THE PORT AUTHORITY OF NY & NJ

ADDENDUM #5

TO PROSPECTIVE BIDDER(S) ON **BID # MCP-254.254 (RFx 7*453) – (FTA) – Port Authority Bus Terminal – Midtown Bus Terminal Replacement Program – Dyer Deck-Overs**

The following changes/modifications are hereby made to the solicitation documents:

20240408_MTBTR_DD _ RFI 50_Sketch

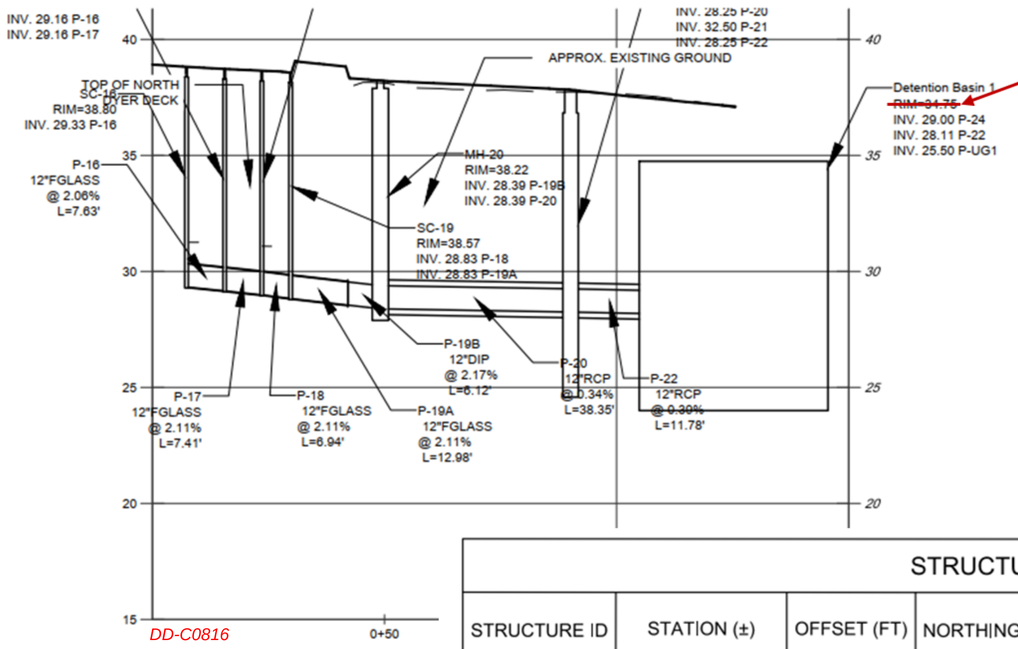
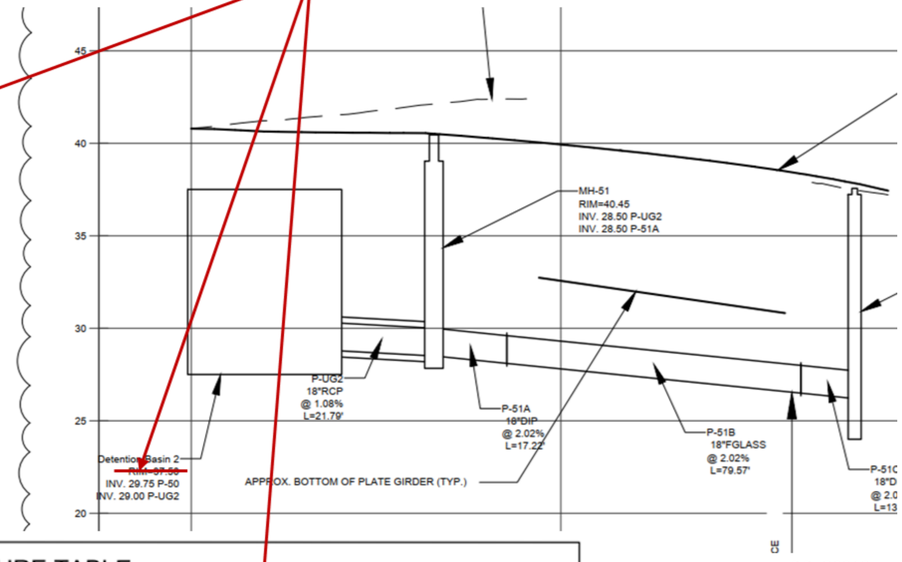
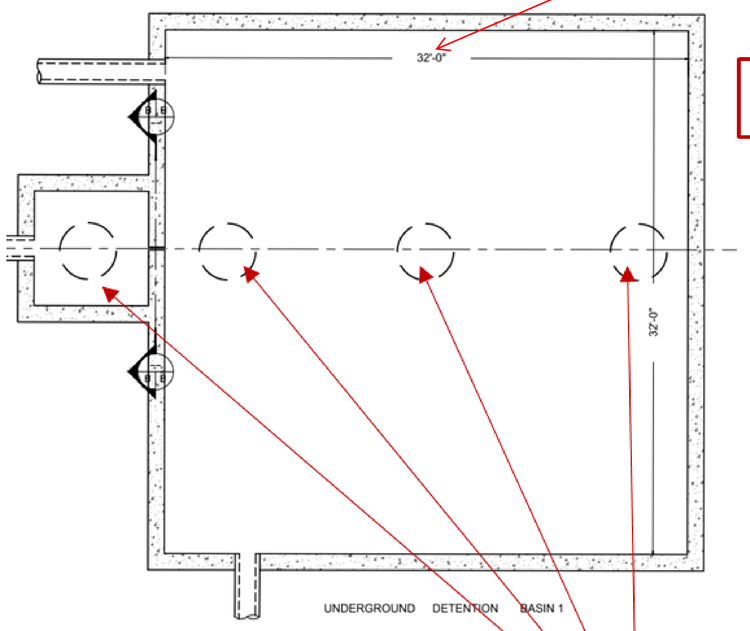
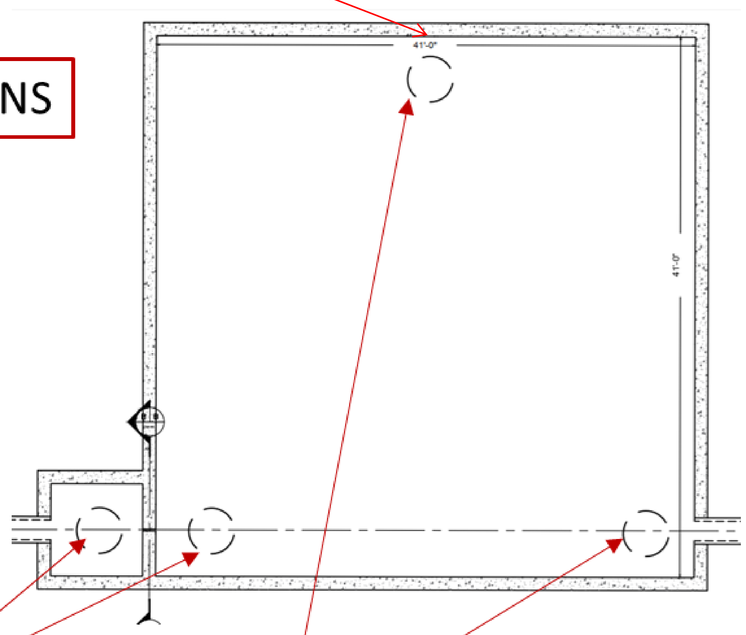
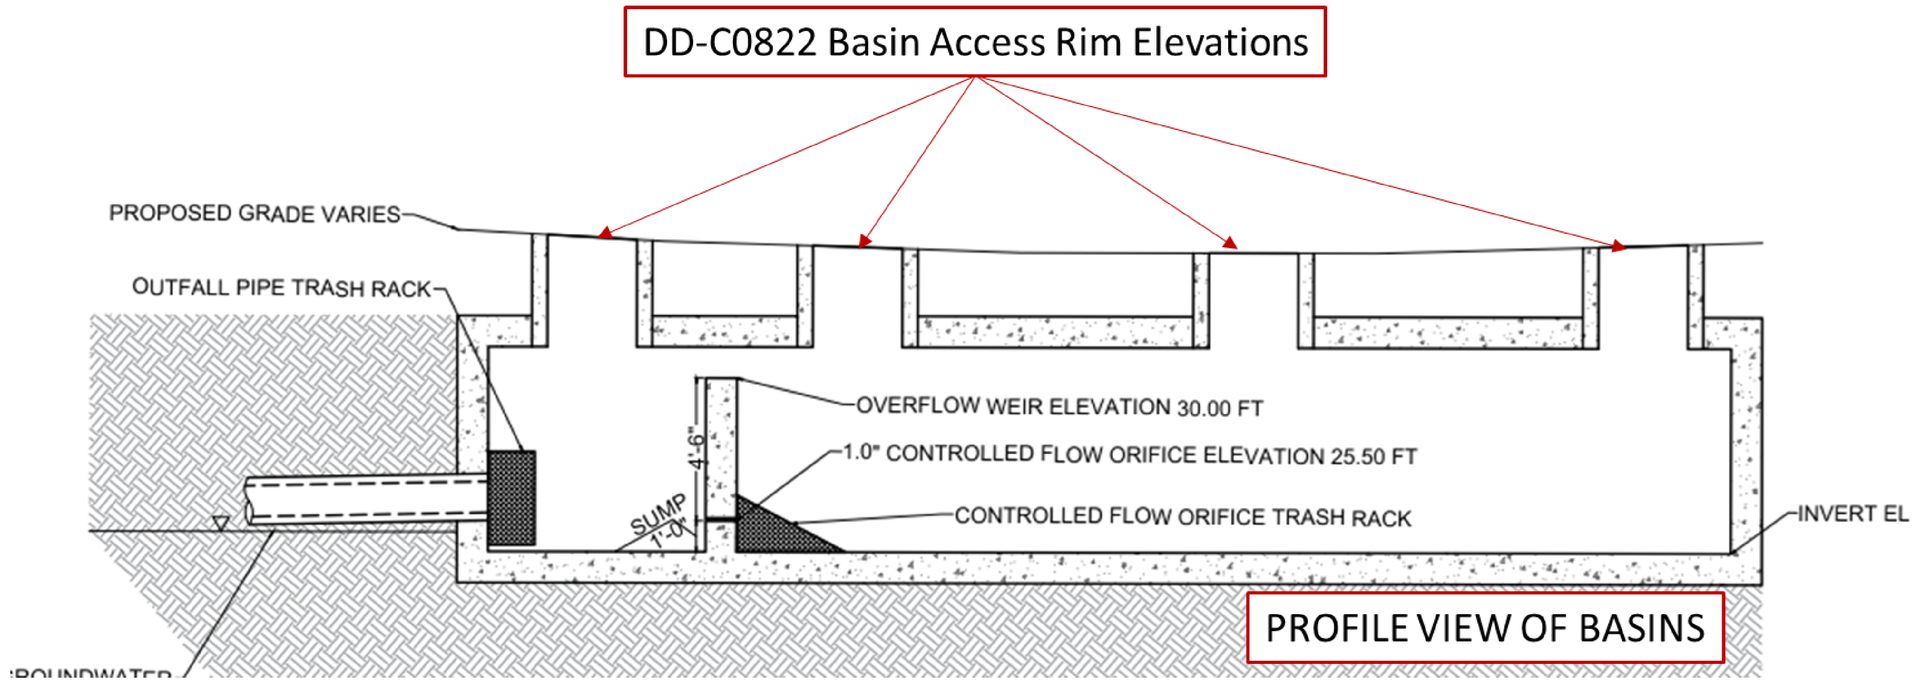
Question #50	Reference the Drainage Profiles on Contract Drawings DD-C-0815 through DD-C0818 and the Drainage Tables on contract Drawings DD-C-0821 through DD-C0823. After review of the profiles and the tables it appears in several areas the "Rim Elevation" called out in the tables are not reflected in the profiles (i.e., Detention Basin 1 Rim Elevation shown in the Drainage Tables is EL 34.75, however the profile drawings for Detention Basin 1 appear to show that the RIM Elevation should be at +/- EL 37.00). Such discrepancies between the drainage Tables and the Profiles are prevalent. Please review the RIM Elevations shown in the Drainage Tables and the Apparent RIM Elevations shown in the Drainage Profiles and clarify and make any corrections that are required.

RIM elevations to be removed

NOTE: SEE REVISED DRAWINGS DD-C0851 AND DD-C0852 FOR UPDATED DIMENSIONS ON DETENTION BASINS

Answer #50	Rim Elevations shown in the drainage tables and the drainage profile were reviewed and all but the Detention Basins match between the two. The detention basins in the profiles are only visual representations of the location of the buried portion of the basins and should not have a Rim associated with them. Refer to DD-S3101 through DD-S3106 for the structural design of the basin. Refer to DD-C0822 Table "Structure Table – Basin Access" for the rim elevations of the basin access manholes. Please see the sketch "20240408_MTBTR_DD_RFI 50 Sketch" for further clarification.

DRAINAGE PLAN
UPPER LEVEL
SHEET 1

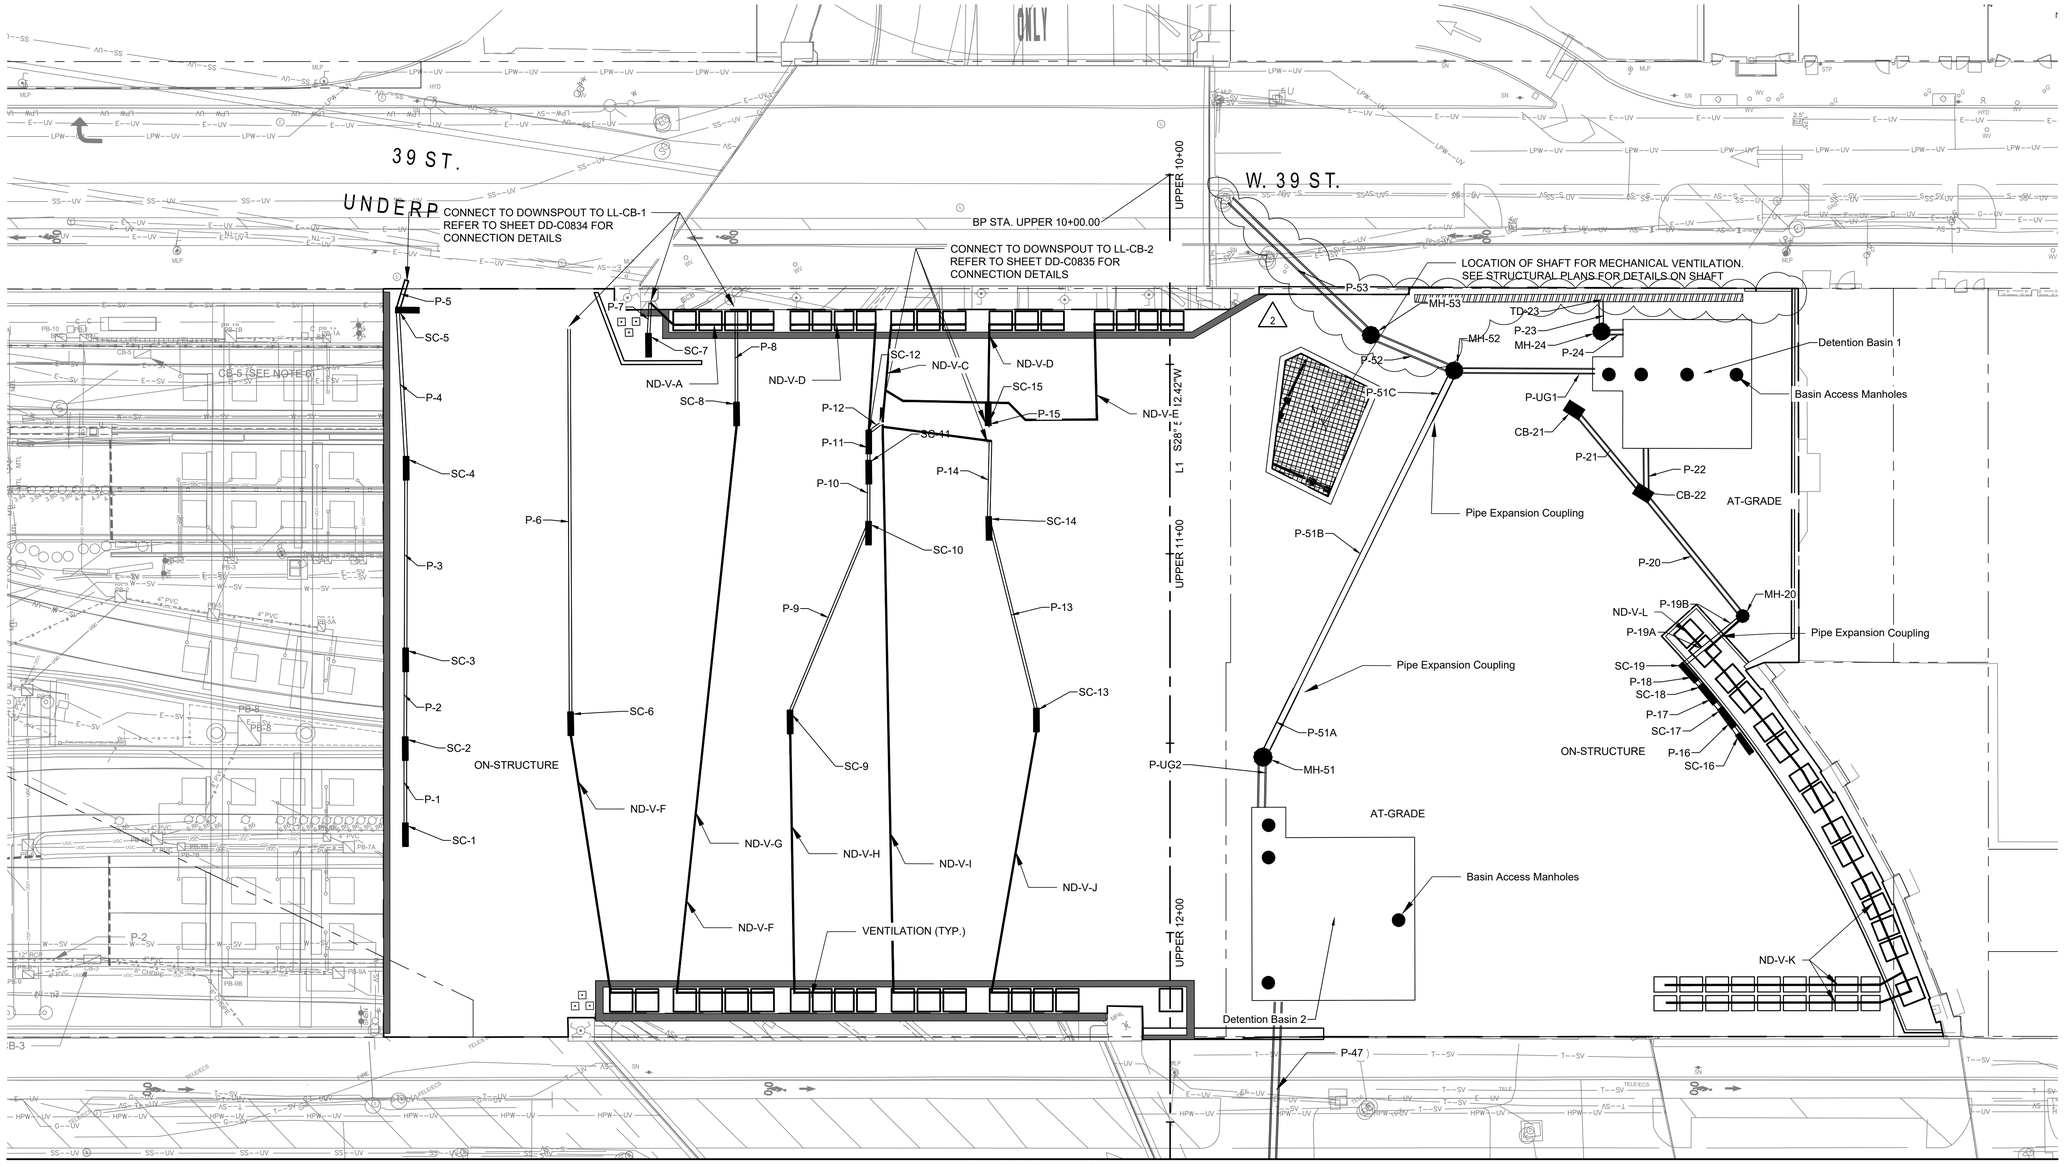
Question #49	Contract Drawings DD-C0811 & DD-C0812 show piping with the designation "ND-V" (i.e., ND-V-A, ND-V-B, ND-V-C, etc.). The Drainage Tables & Drainage Profiles do not show this designated piping. Please clarify what is the piping "ND-V" and provide Specifications for such piping, Drainage Tables for such piping and Drainage Profiles for such piping and any other pertinent information that is required for bidding purposes.

Answer #49	Piping with designation "ND-V" is the piping required to drain the ventilator boxes. Note will be added to plans: "Piping with designation "ND-V" is the piping required to drain the ventilator boxes, provided paths are diagrammatic. Contractor is to coordinate with ventilator manufacturer to determine final layout of the piping. Layout is to be coordinated with the final selected ventilator. Contractor shall submit pipe routing and shop drawings for approval. Drainage elements and associated supports for ventilator boxes shall comply with specification 334170 Bridge Drainage System or an alternative proposed by the manufacturer and approved by the Engineer"

STORMWATER MANAGEMENT DETAILS SHEET 1

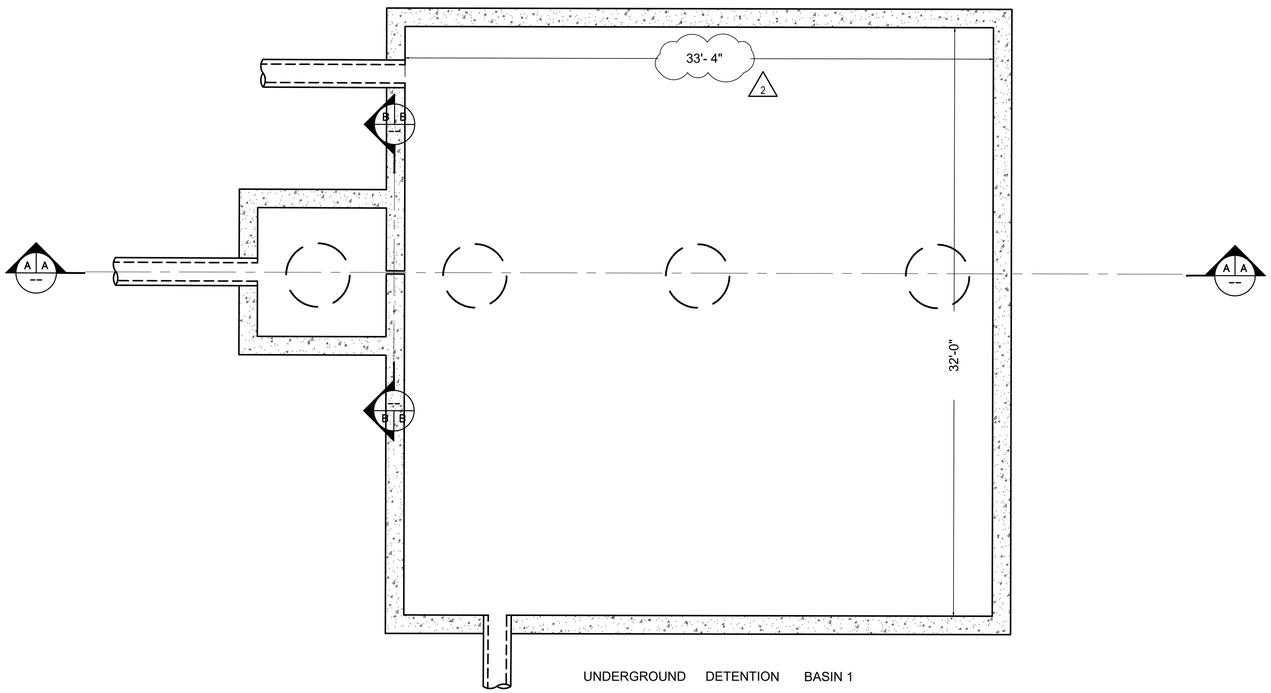
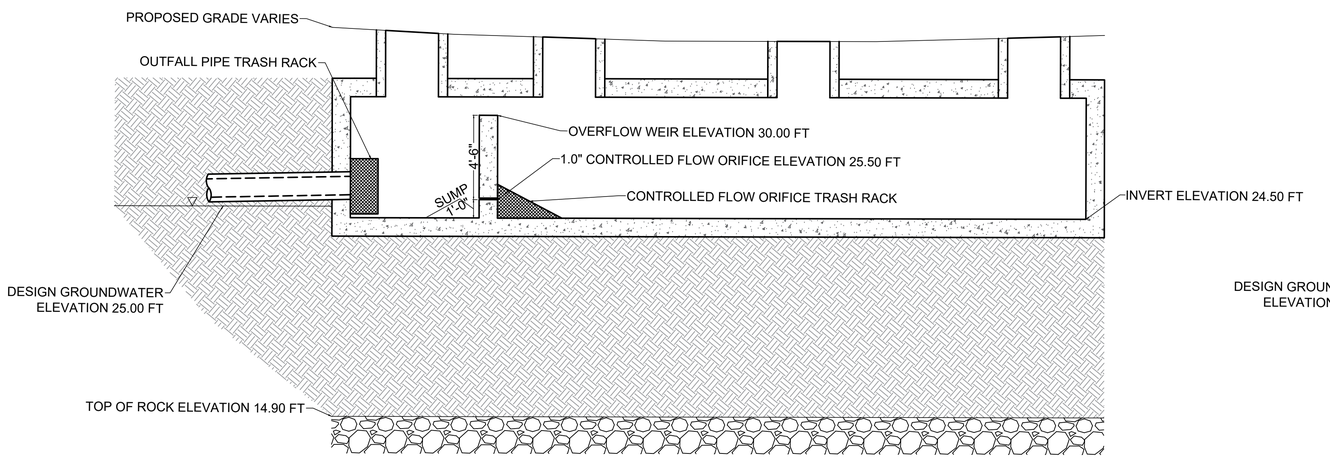
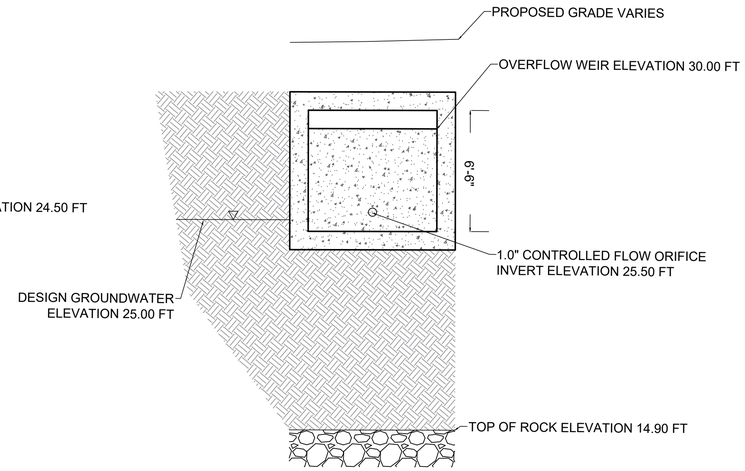
Question #45	Contract Drawing DD-C0851 and DD-C-0852, shows the overall dimensions and elevations of the underground Detention Basin 1 and Detention Basin 2. These drawings show that the bottom of the Detention Basin bottom footing slab is at the same elevation as the "Weir Chamber" bottom footing slab. The structural drawings for Detention Basin 1 and Detention Basin 2 show the "Weir Chamber" cross section details on Section 3 on DD-S3102 and Section 3 on DD-S3105. This cross section appears to dimensionally show that the Weir Chamber overall depth is deeper than the Detention Basin. This appears to conflict with elevations shown in the Drainage Tables and in the Storm Management Details shown on DD-C0822 and DD-C0851 and DD-C0852. Please clarify the correct dimensions for the "Weir Chambers".

Answer #53	Refer to response to RFI Question #51.
Question #54	Contract Drawings DD-C0851 and DD-C0852 show the overall height of the Weir Wall height to be 5.5 ft. Contract Drawings DD-S3102 and DD-S3105 show that the Weir Wall height to be 4.5 ft. Please clarify and advise.

Answer #45	Refer to revised drawings DD-S3102 and DD-S3105 provided in this addendum. Note two dimensions are changed, all other dimensions remain as is. The bottom of the weir chamber matches the bottom tank.

Answer #54	Weir Wall height in Contract Drawings DD-C0851 and DD-C0852 are correct. DD-S3102 and DD-S3105 is revised to show Weir Wall height to be 5.5 ft in this addendum.
